Summary of Changes

Consented Scheme
REF: 2018/0470/P

Project
 87 Frogna

Drawing Title
 Proposed Sections

Consented Section AA
1:100

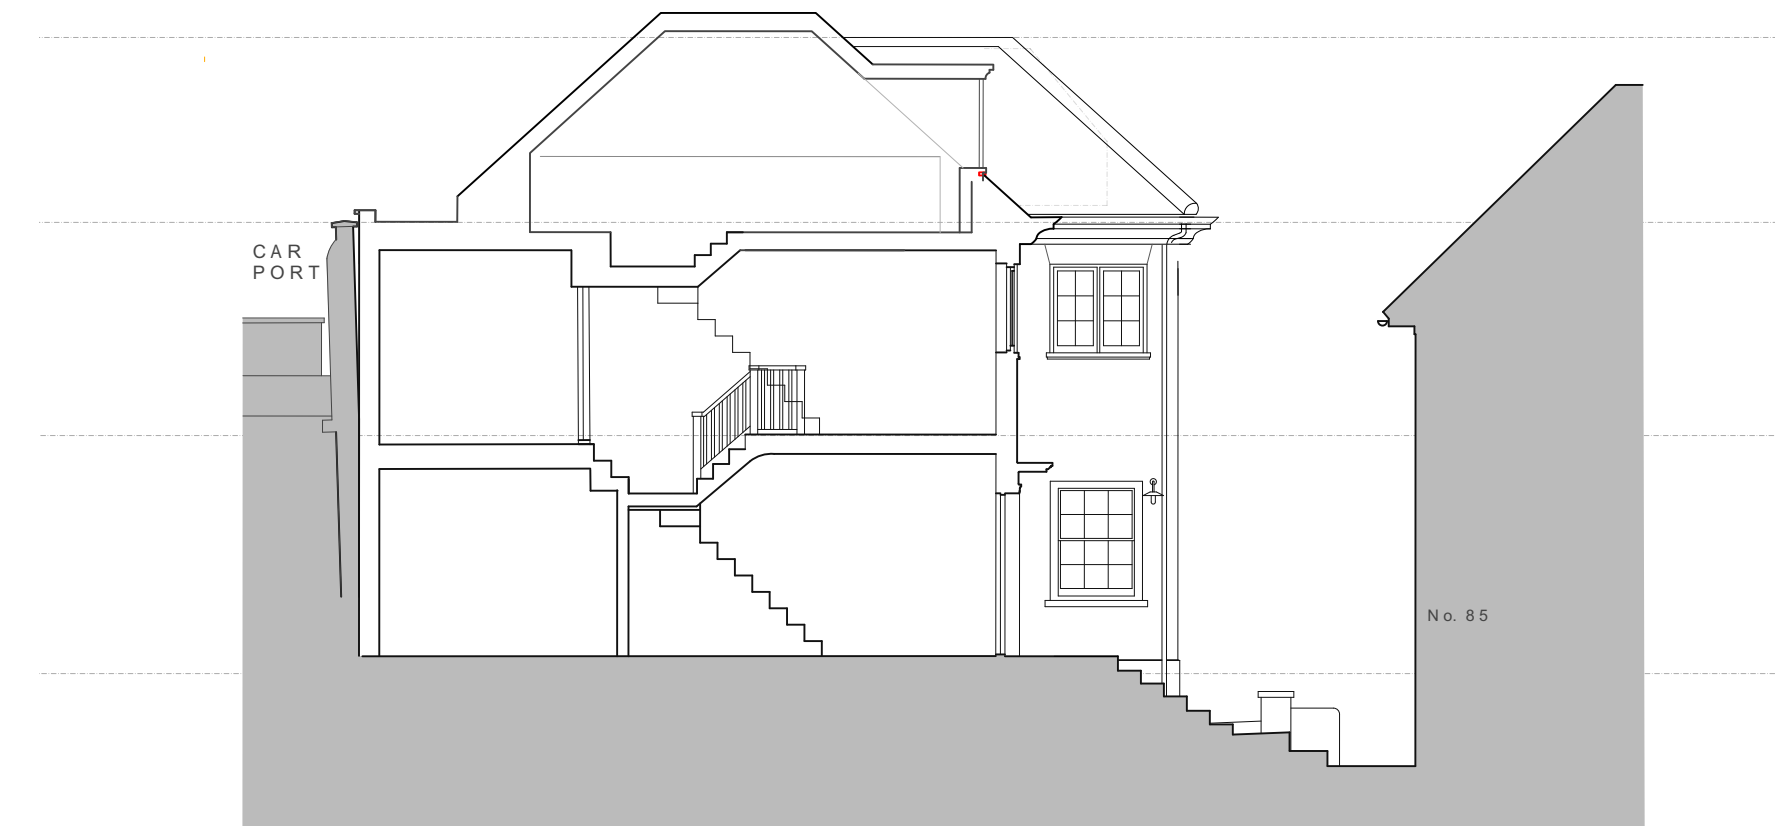
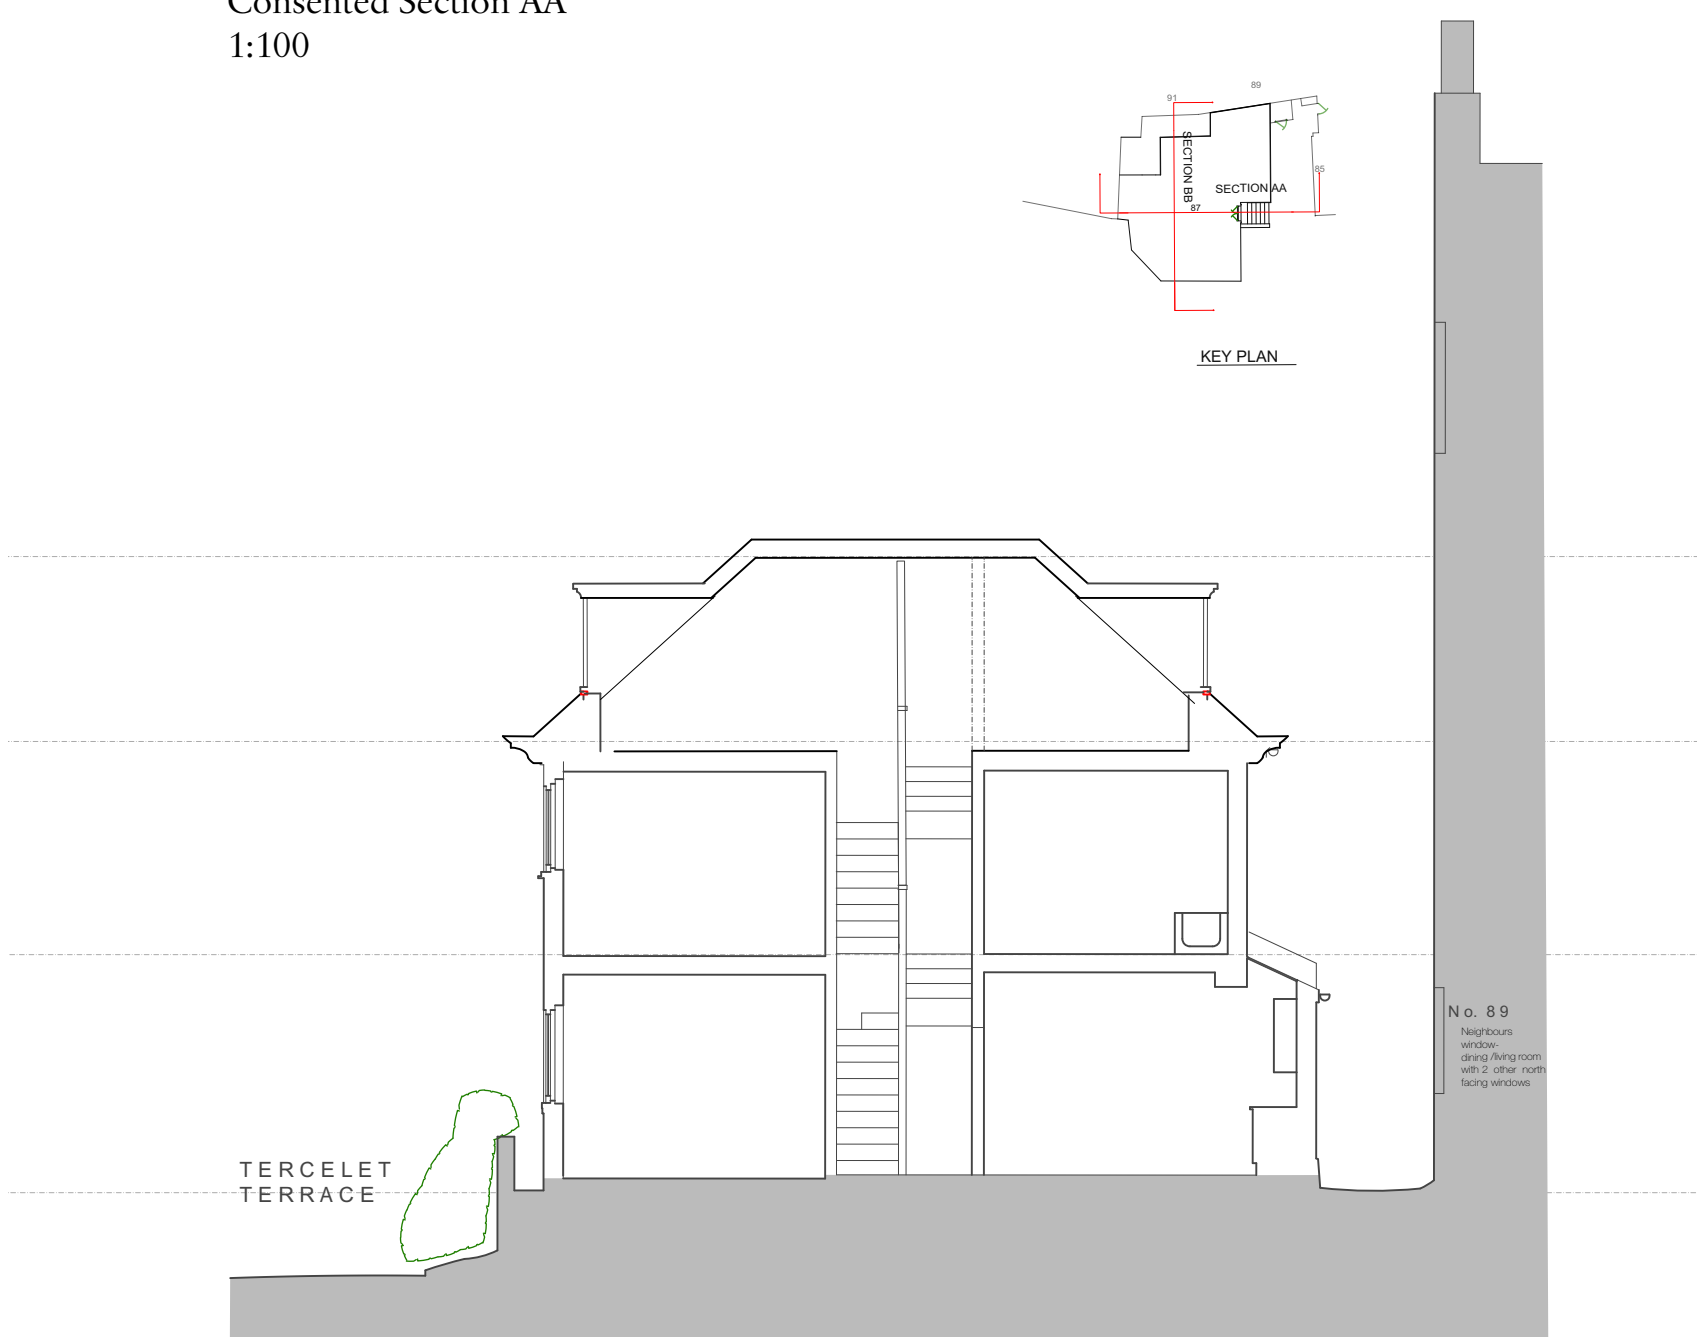
Section AA - North Extension extended over 1F, front stairs moved back 850mm.

Proposed Section BB
1:100

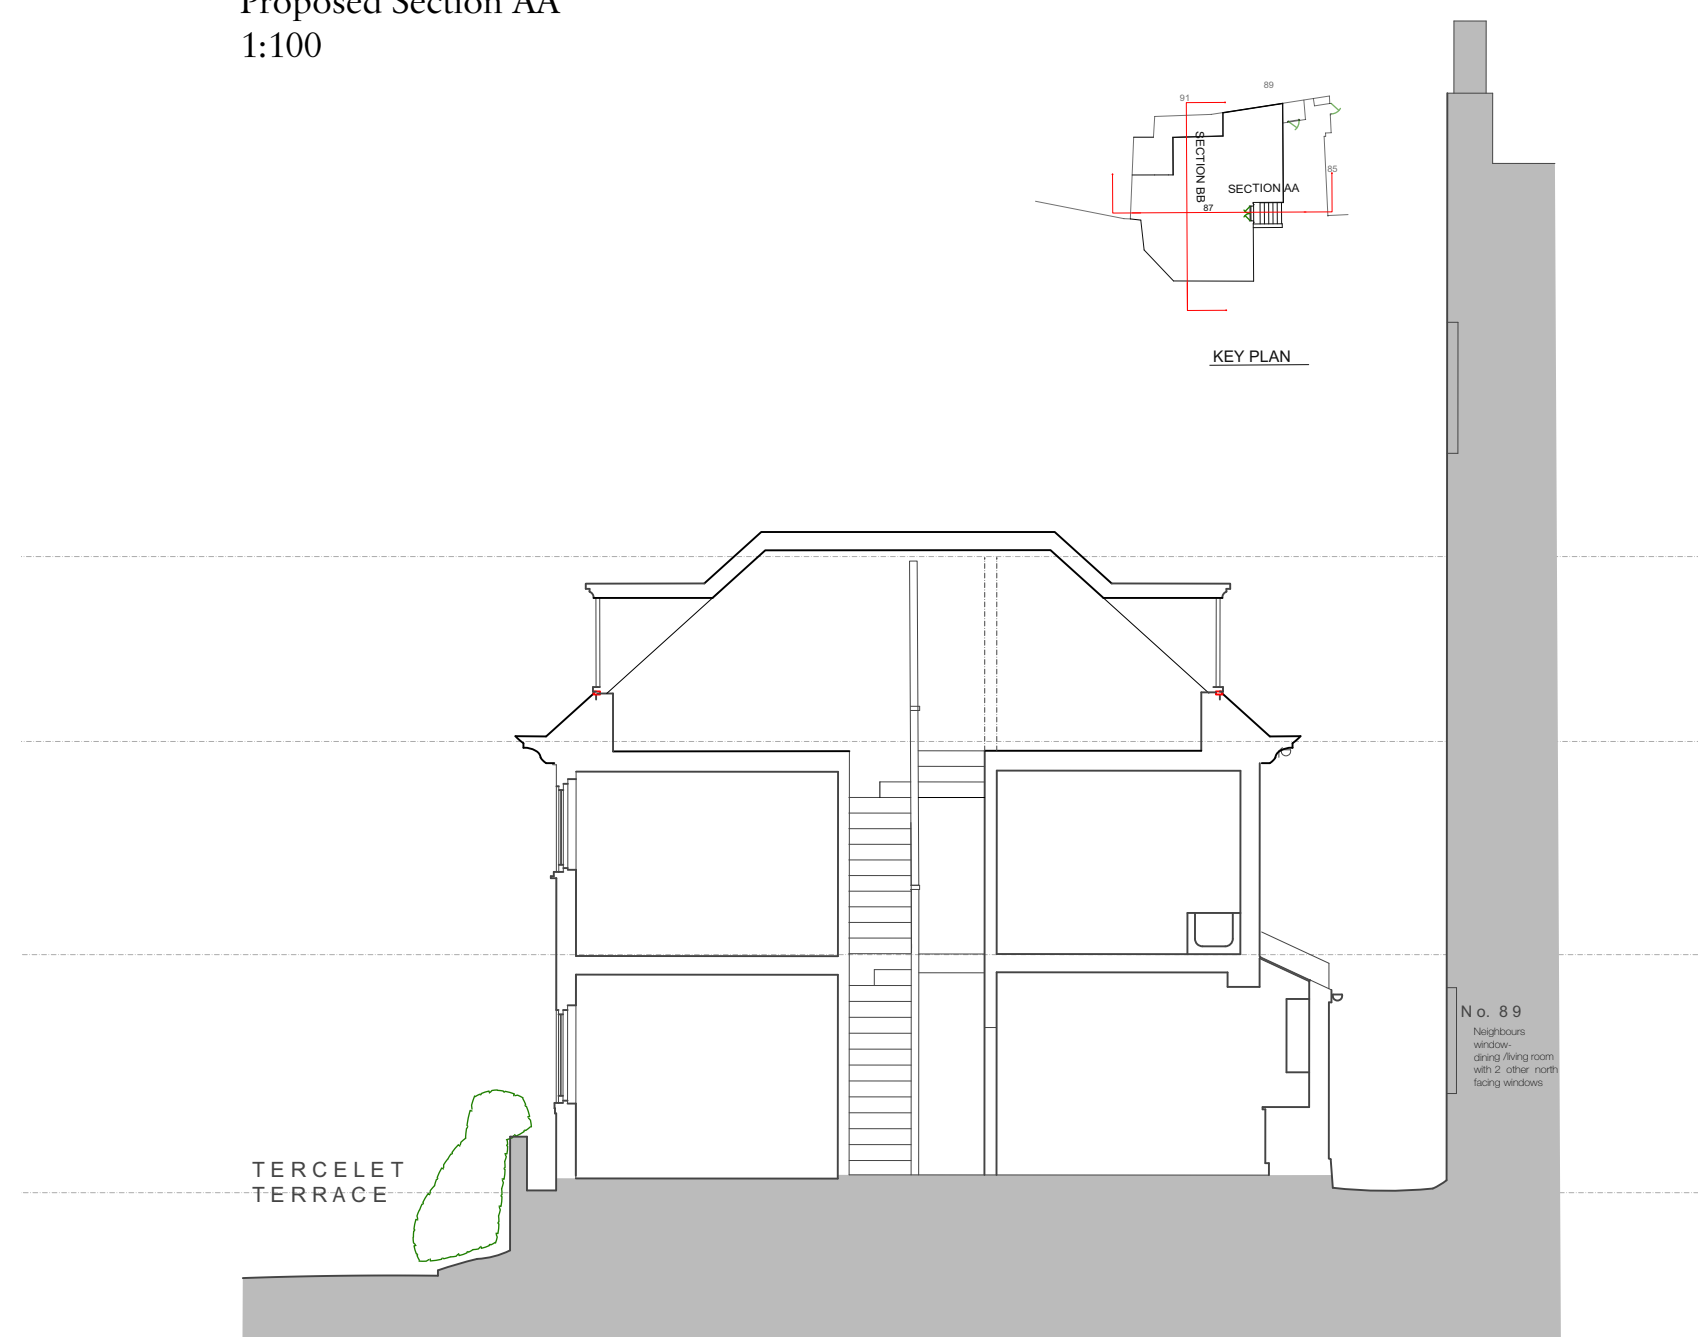
Section BB - Internal Stair arrangement changed.
